Amendments to the Drawings:

FIGURE 2

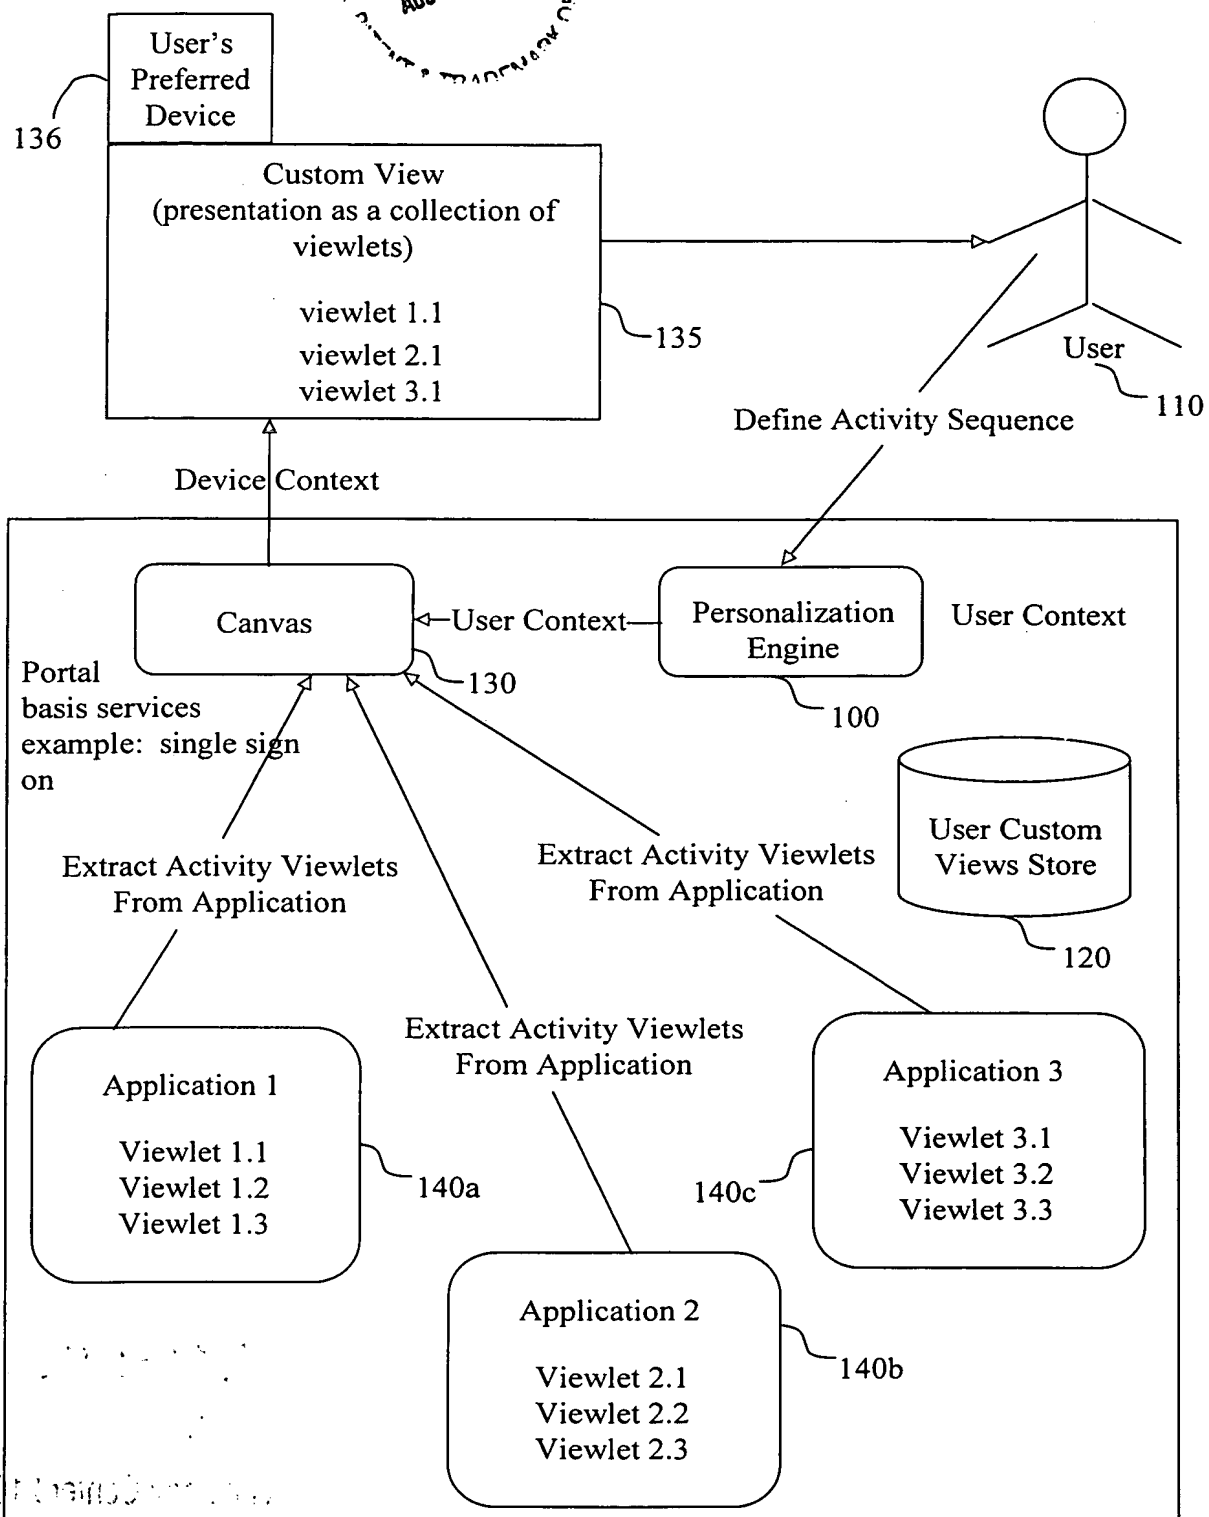
Element 140a label "Viewlet 4.1" is changed to --Viewlet 1.1--.
